RECORD OF DECISION

Former Garden Photoengraving Co., Inc.
Operable Unit Number 02: Off Site Groundwater and
Soil Vapor
State Superfund Project
Mineola, Nassau County
Site No. 130174
March 2019

Prepared by
Division of Environmental Remediation
New York State Department of Environmental Conservation

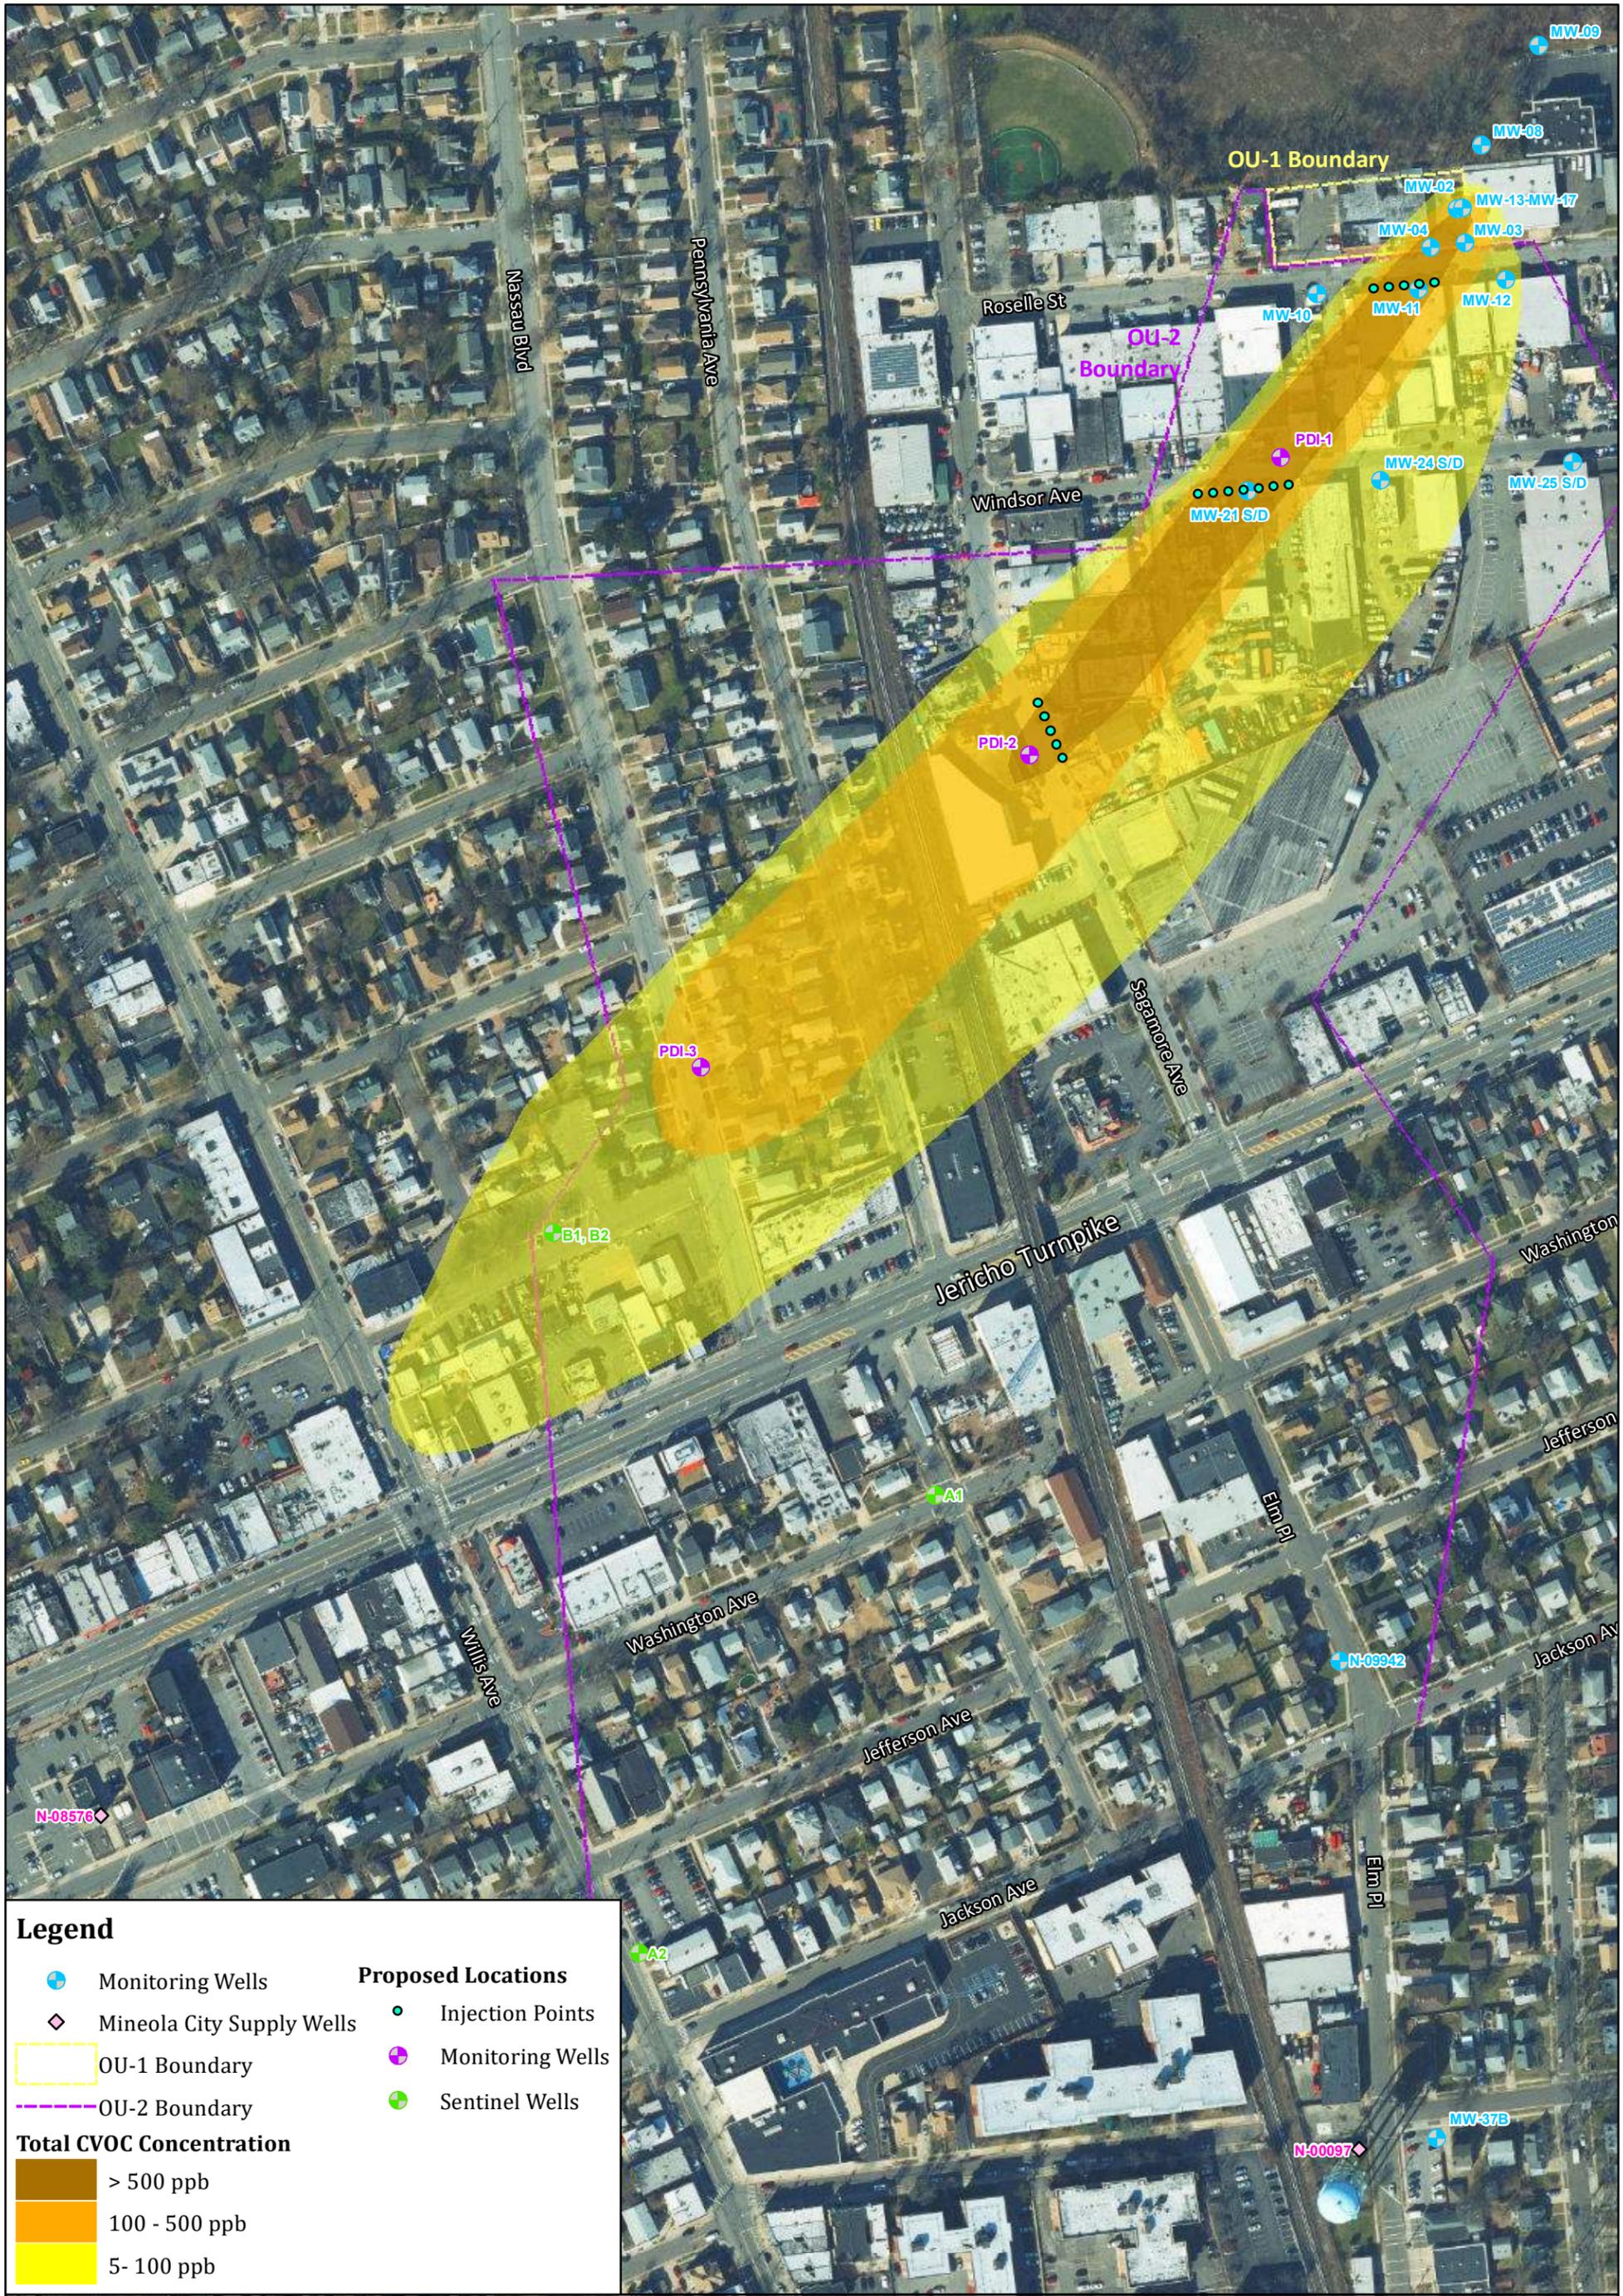
COMMENT 1: The Village of Mineola asked if the DEC-proposed sentinel wells could be installed to a deeper depth (i.e. to the depth of the supply well) that would provide better data to protect their supply wells to the southwest and south of the site. If yes, when will that be done?

COMMENT 7: Regarding the proposed locations of the sentinel wells, the Village agrees with the placement of wells A1 and A2 as shown in the PRAP. Regarding sentinel wells B1 and B2, these wells are shown to be within the projected location of the plume, and while the Village agrees with these locations, we would also recommend and request that an additional one or two wells be placed between the projected location of the plume and Supply Well 7.

RESPONSE 1: The planned depth of the deep sentinel wells are 330 ft below ground surface (bgs) to understand contamination heading in the direction of Supply Well 1, and 480 ft bgs for Supply Well 7. These sentinel wells will be screened at similar depths to the corresponding supply wells. Based on the regional groundwater model, the well locations and depths will provide the data necessary to protect the supply wells and provide early warning capability. The design of the sentinel wells is planned for this year with installation planned for later in the year.

RESPONSE 7: Sentinel Wells A1 and A2 are proposed for Supply Well 1. Sentinel Wells B1 and B2 are proposed for Supply Well 7. A groundwater model was developed for the regional groundwater in the area of the Former Garden Photoengraving Site and the Supply Wells 1 and 7. Based on this groundwater model, Sentinel Well B1 would be screened in the middle portion of the Magothy aquifer at approximately 180 ft bgs. The simulated travel time from this location and depth to Well 7 is approximately 3-4 years. Sentinel Well B2 would be screened in the basal portion of the Magothy, at a similar depth as Supply Well 7 (480 ft bgs). The groundwater model suggests a travel time from this location and depth to the Supply Well 7 of approximately one year. In light of the request, the Department will consider another sentinel well location and depth, during the design of the remedy.
